ADDENDUM NO. 002

RE: Bristol Community Health Center, Phase I Renovations
For Southwest Virginia Community Health Systems
T&L Project No. 16493

DATE: April 4, 2023

Sheet No. **S001**

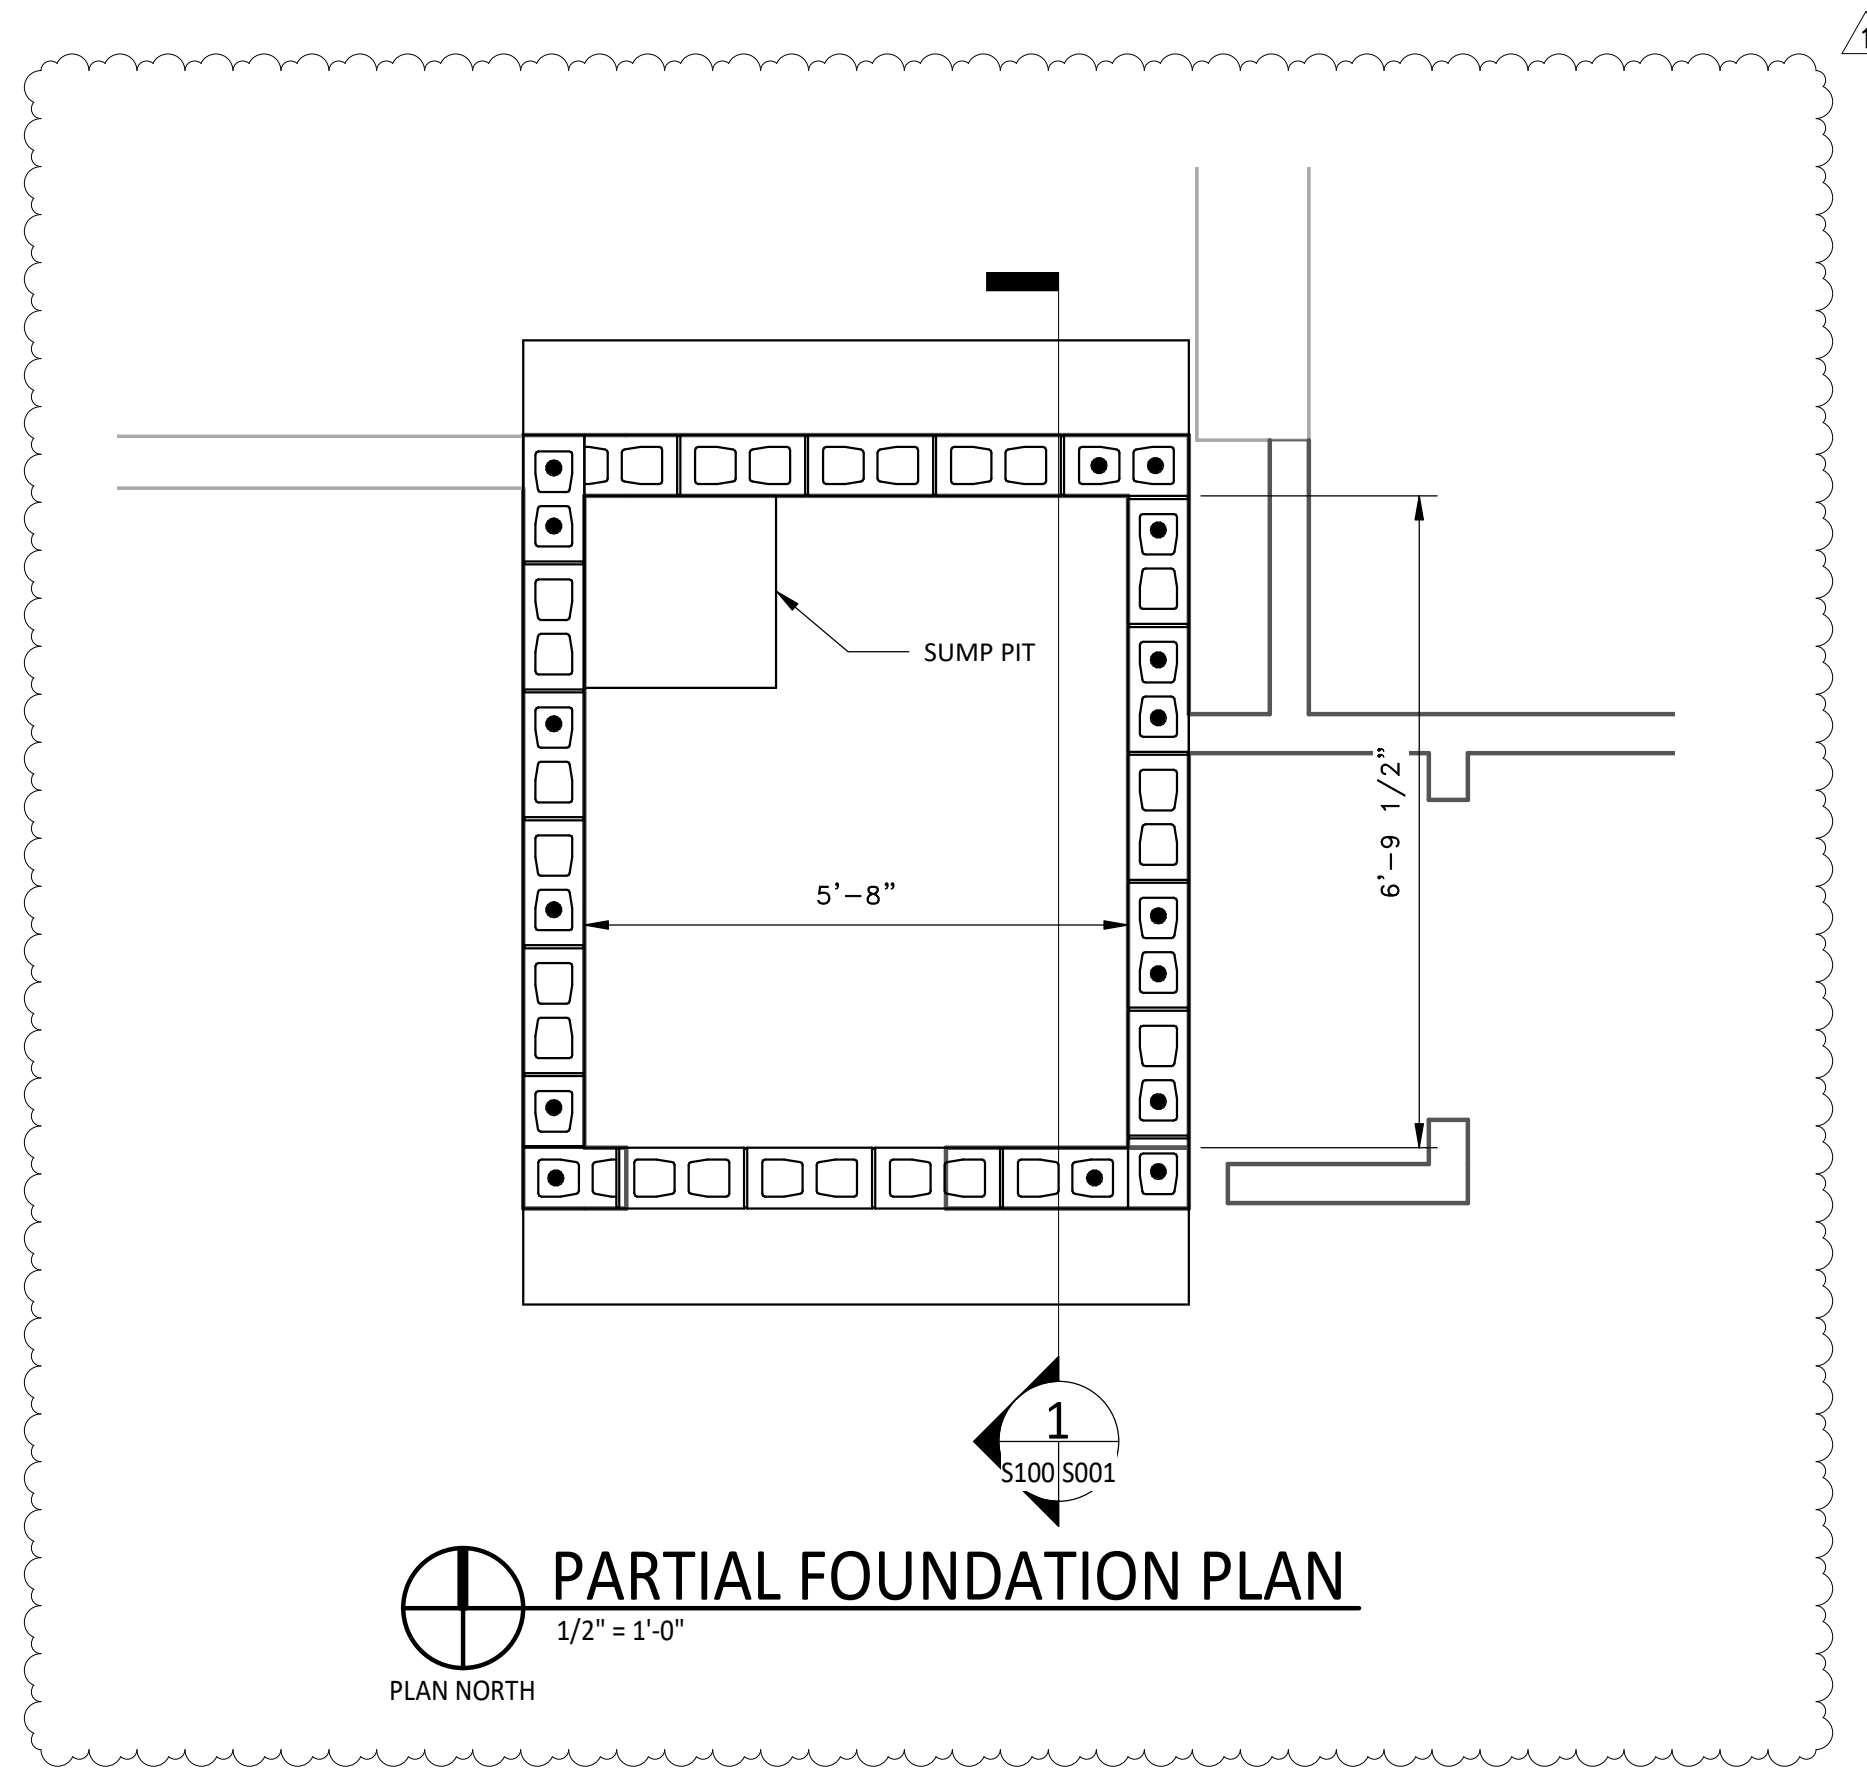
1. The elevator shaft foundation may be reduced to the out-to-out dimension in the plan east-west direction. Keep the foundation extension in the plan north-south direction. Refer to revised Structural drawings.
2. Refer to Sketches ASK-07 thru ASK-09 for details associated with Aluminum Storefront Elevation (SF-4) located in existing exterior wall. Coordinate these sketches with revisions noted below and on enclosed Structural drawing S001.

4. Refer to Drawing A103 for revisions to reflected ceiling at relocated elevator Machine Room 161 and Vestibule 162.
5. Refer to Drawing A601 for revisions and clarifications at elevator and machine room.
6. Refer to Drawing A201 for revised number and spacing of Aluminum Storefront Elevation (SF-4) and locations of wall cap WC-1, and louvers L-1 & L-2.
7. Refer to Drawing A701. Add new note no. 9 to General Partition Notes that reads, "Provide new 2-1/2" metal Z-furring at Partition Type A0.
8. Refer to Drawing A713 for revised Aluminum Storefront Elevation (SF-4).
9. Refer to Drawing S001 for "Typical Detail – Slab Replacement @ Utility Trench" and "Typical Detail – New Window Opening Existing Exterior Wall".
10. Refer to Drawing S100 for revised elevator shaft plan revisions.
